Model	CSO-α (USA only)	Date of Modification
Modified Article	PCB-FCU	Expected Date
Reason for Modification	<input type="checkbox"/> Parts catalog correction <input type="checkbox"/> Vender change To disable installing the memory card on CSO-α <input type="checkbox"/> To meet standartds () <input type="checkbox"/> Part standardization <input type="checkbox"/> To facilitate assembly <input type="checkbox"/> To increase reliability <input checked="" type="checkbox"/> Other	Execution Date
		From 1st mass production of January '92

MODIIFICATION BULLETIN NO. CSO-002

ISSUED ON March 26th, 1992

REISSUED ON June 15th, 1995**MODIFICATION BULLETIN NO. CSO-050**ISSUED ON April 9th, 1993

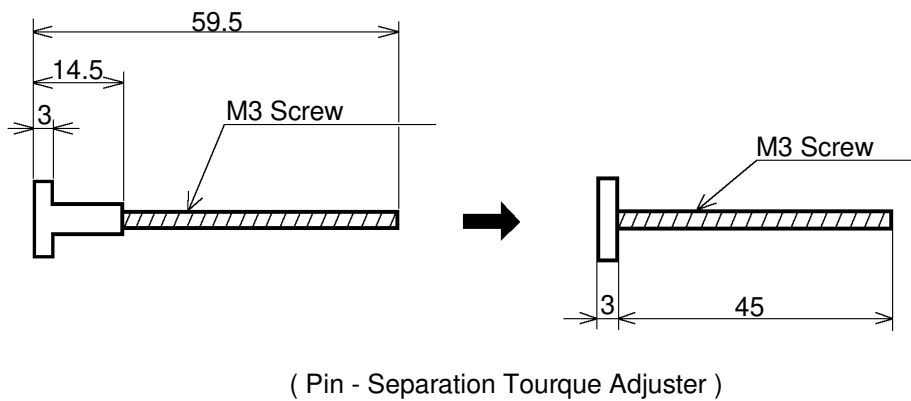
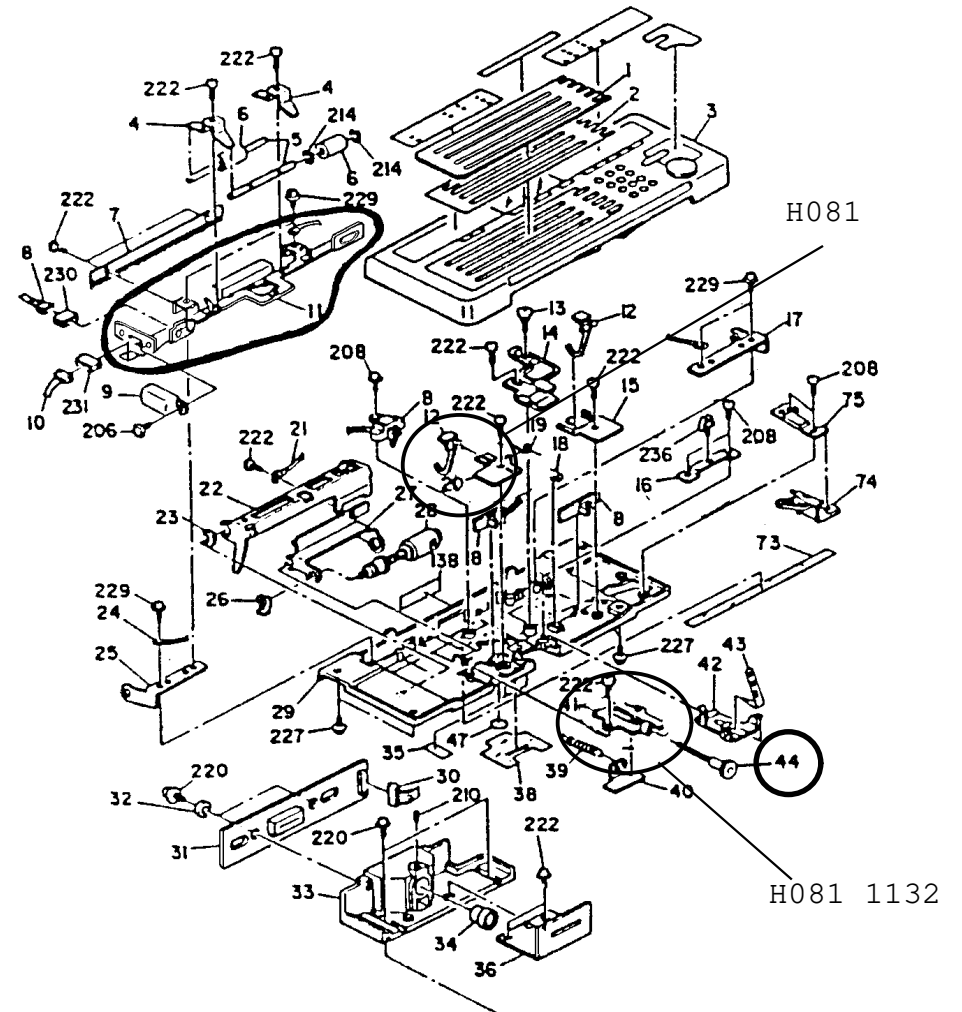
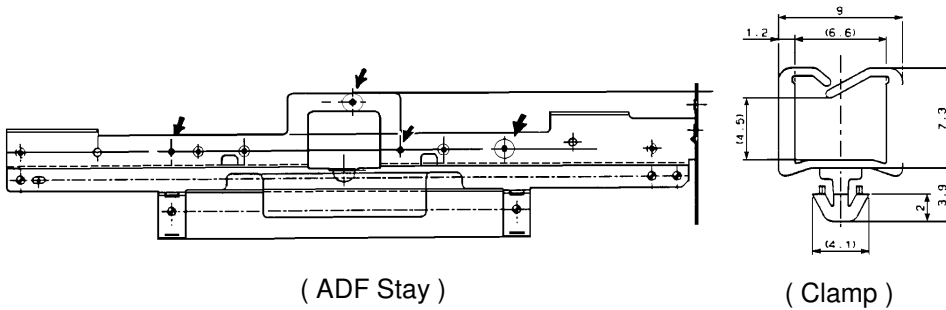
Model	CSO All models					Date of Modification	
Modified Article	S1 Bracket					Expected Date	
Reason for Modification	<input type="checkbox"/> Parts catalog correction <input type="checkbox"/> To meet standards () <input type="checkbox"/> To facilitate assembly <input type="checkbox"/> Vender change <input checked="" type="checkbox"/> Part standardization <input type="checkbox"/> To improve reliability <input type="checkbox"/> Other					From Feb. productions in 1993.	
1. The S1 bracket and the bracket - Separation torque adjuster have been combined. 2. The clamp on the ADF stay ass'y from metal to plastic.

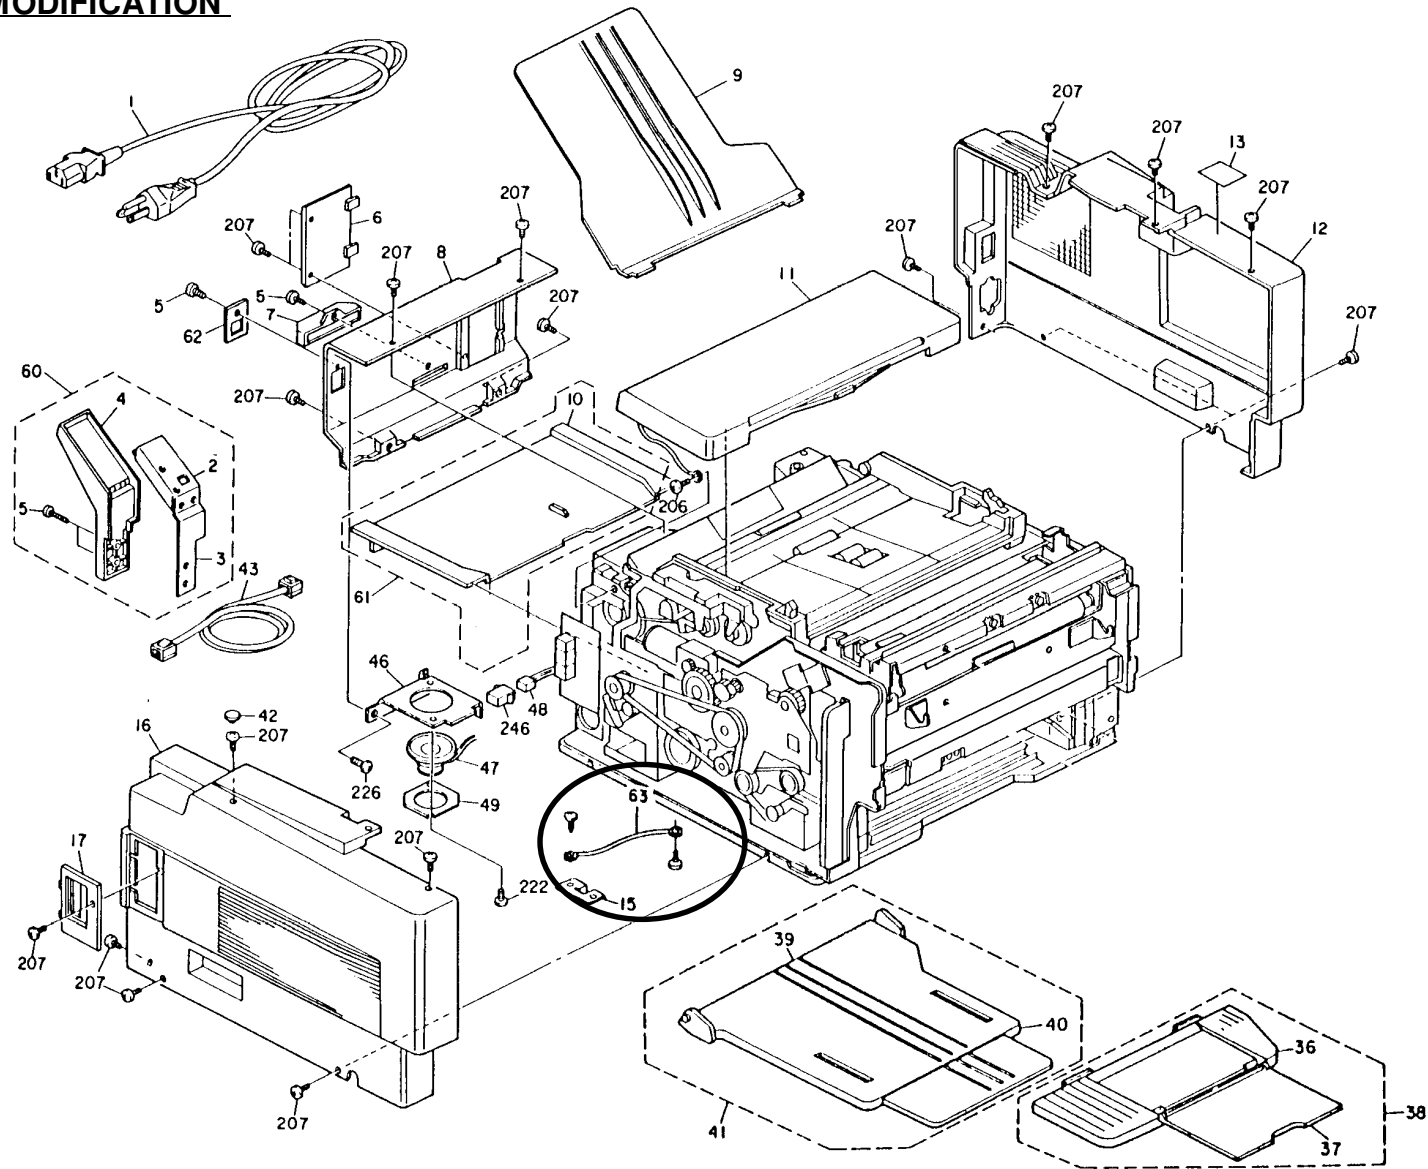
Model	CSO (USA and Asia)					Date of Modification	
Modified Article	ADF Wire					Execution Date	
Reason for Modification	<input type="checkbox"/> Parts catalog correction <input checked="" type="checkbox"/> To meet standards () <input type="checkbox"/> To facilitate assembly <input type="checkbox"/> Vender change <input type="checkbox"/> Part standardization <input type="checkbox"/> To improve reliability <input type="checkbox"/> Other					From the first production of May, '93.	
To meet the UL standards, the following parts have been added.							
Old Part No.	New Part No.	Description	Q'ty Used Old → New	Interchange- ability	Remarks	Parts Catalog	
						Index No.	Page
	H081 1023	Stopper Bracket: ADF	0 → 1			15	1 - 2
	H082 1061	ADF Wire	0 → 1			63	1 - 2
<div style="text-align: right;"> H.Motojima Assistant General Manager FTS Sect. TS Dept. </div>

MODIFICATION BULLETIN NO. CSO-054

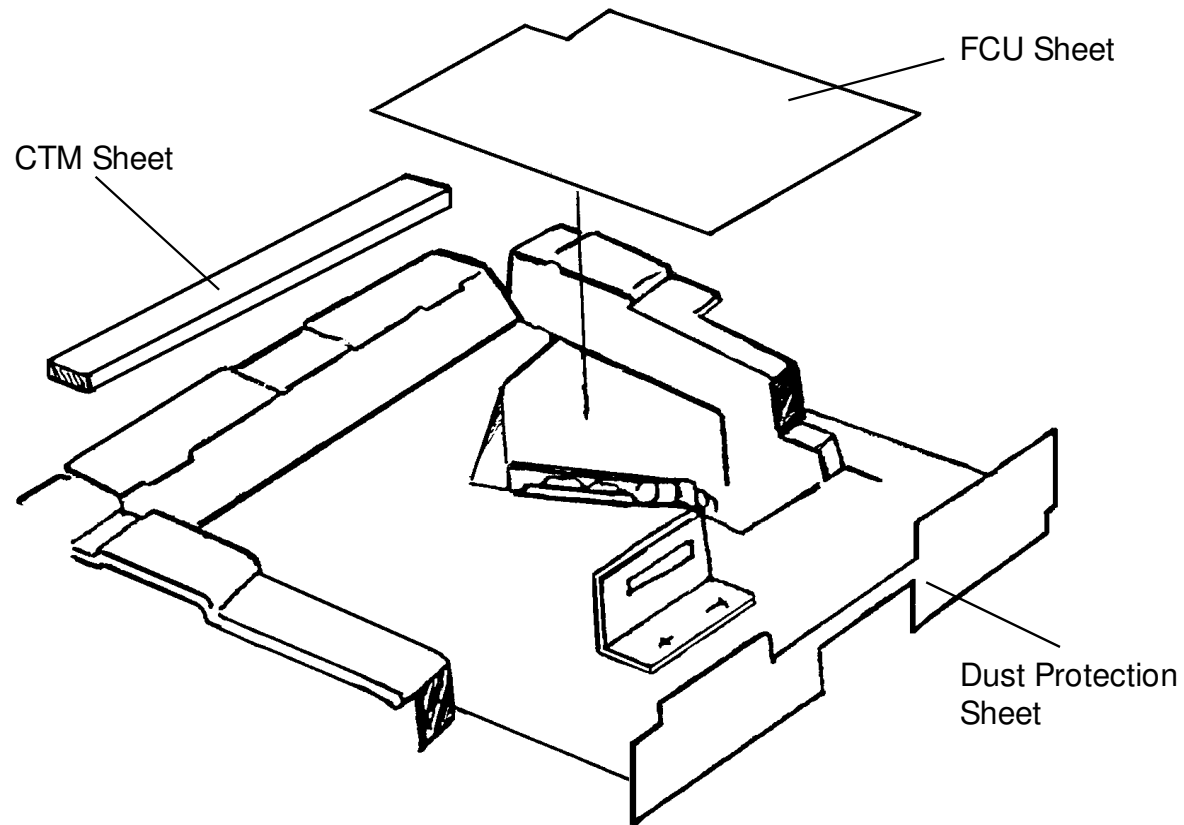
Model		CSO all models				Date of Modification	
Modified Article		Sheet				Execution Date	
Reason for Modification		<input type="checkbox"/> Parts catalog correction <input type="checkbox"/> To meet standards () <input type="checkbox"/> To facilitate assembly <input type="checkbox"/> Vender change <input type="checkbox"/> Part standardization <input checked="" type="checkbox"/> To improve reliability <input type="checkbox"/> Other				From May productions	
		To protect the mirror from becoming dirty.					
Old Part No.	New Part No.	Description	Q'ty Used Old → New	Interchange- ability	Remarks	Parts Catalog	
						Index No.	Page
	H081 1236	CTM Sheet	0 - 1			150	5
	H081 1237	FCU Sheet	0 - 1			151	5
	H081 1238	Dust Protection Sheet	0 - 1			152	5
<div style="text-align: right;"> H.Motojima Assistant General Manager FTS Sect. TS Dept. </div>
